PLANNING & ZONING CASE NO. SP2023-036

SITE PLAN
KENNOR ROCKWALL RETAIL
LOT 8R, BLOCK A
DALTON GOLIAD ADDITION
1.93 ACRES
ROCKWALL, ROCKWALL COUNTY, TEXAS
OCTOBER 20, 2023
CASE #SP2023-0XX

DEPARTMENT	REVIEWER	DATE OF REVIEW	STATUS OF PROJECT
PARKS	Travis Sales	10/24/2023	Approved w/ Comments

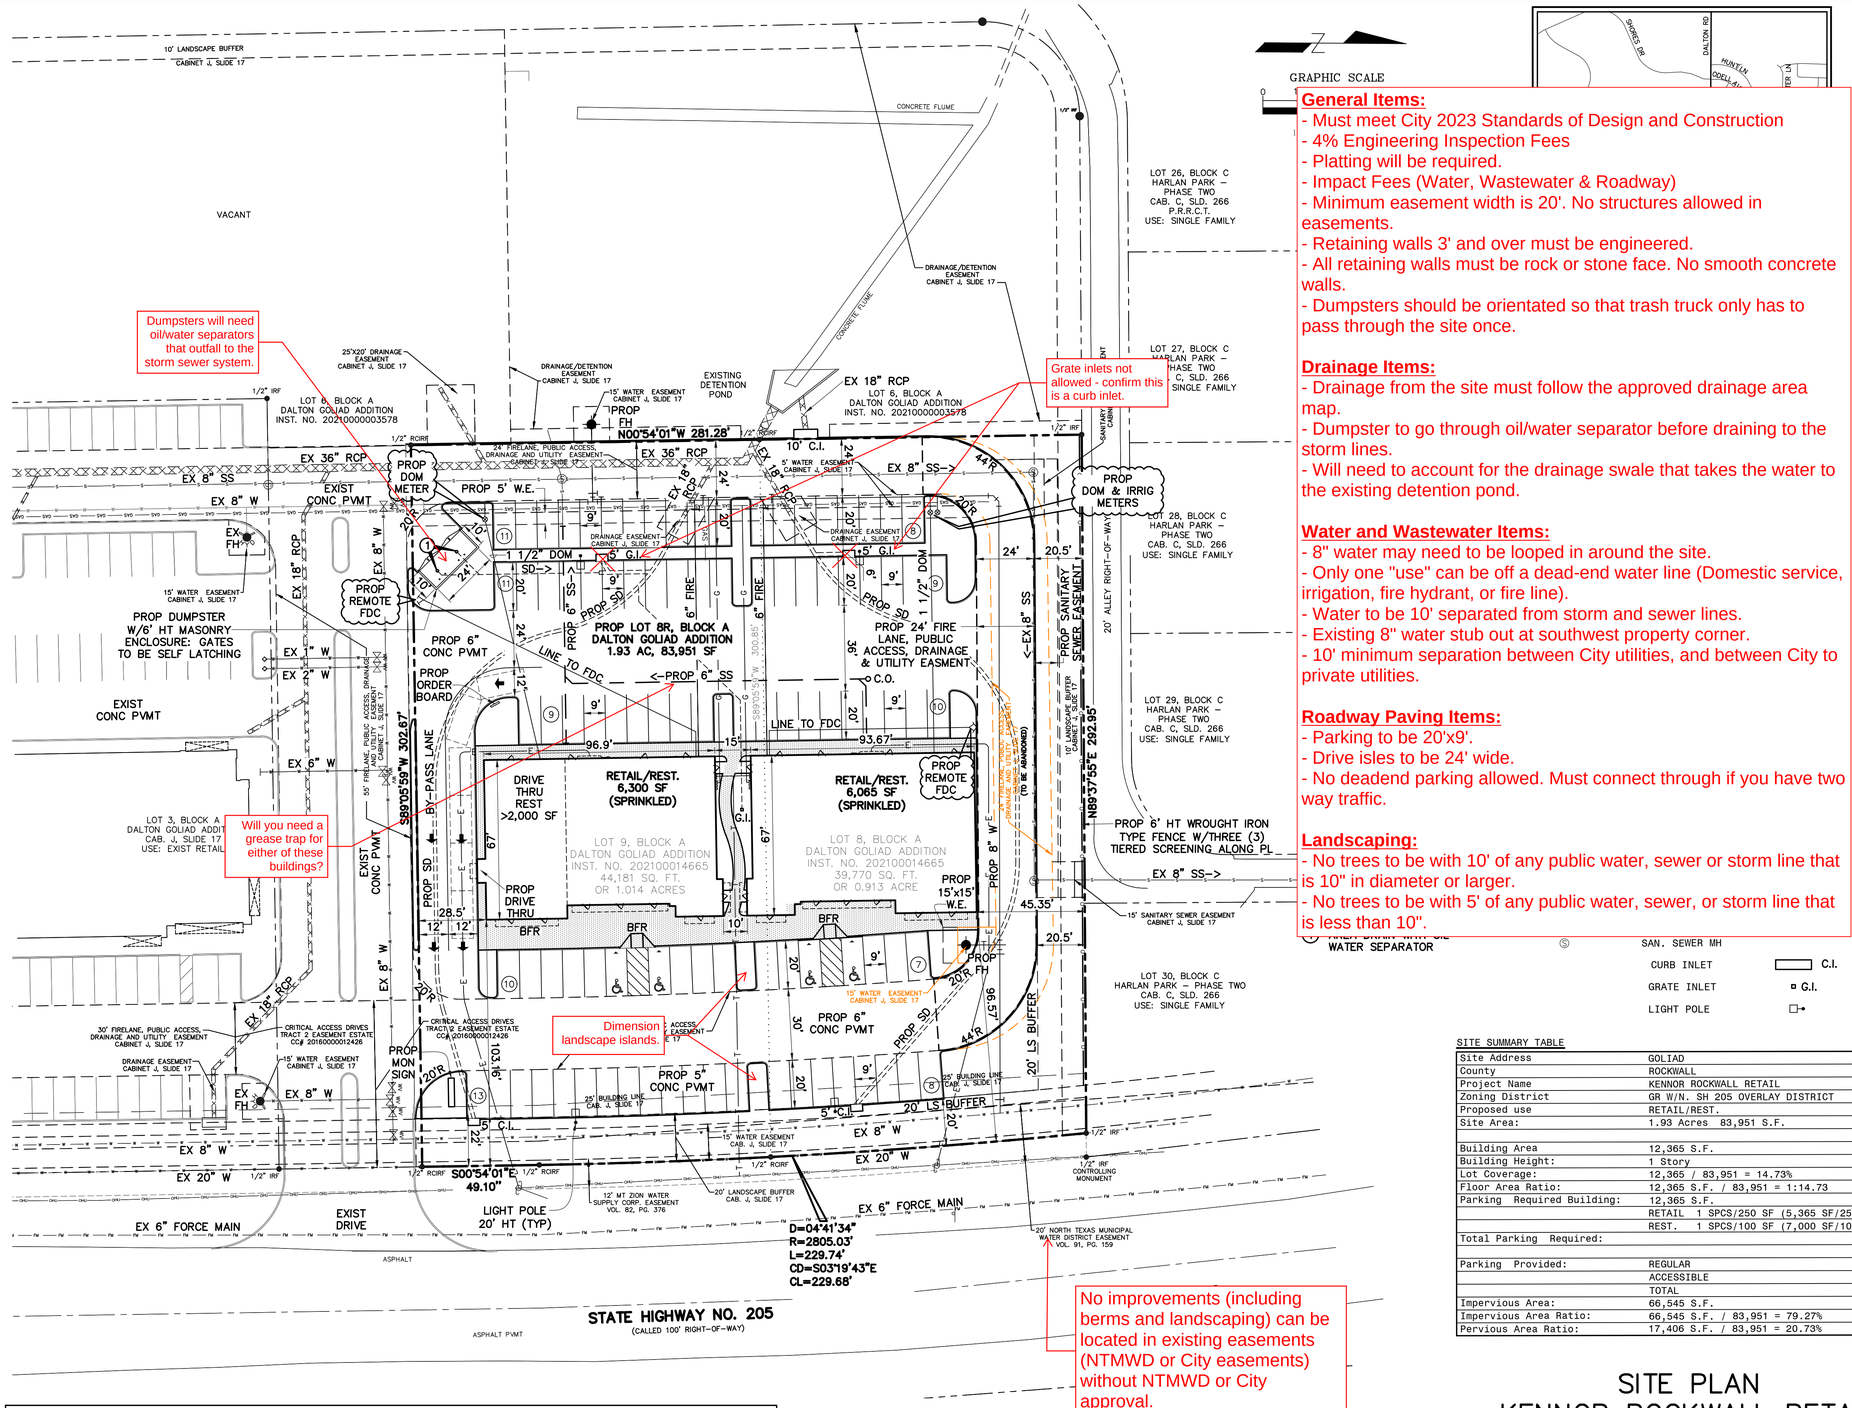
10/24/2023: 1. All canopy/shade trees are required to be 4" caliper minimum.
2. Please ensure all parking spaces are within 80' of tree canopy
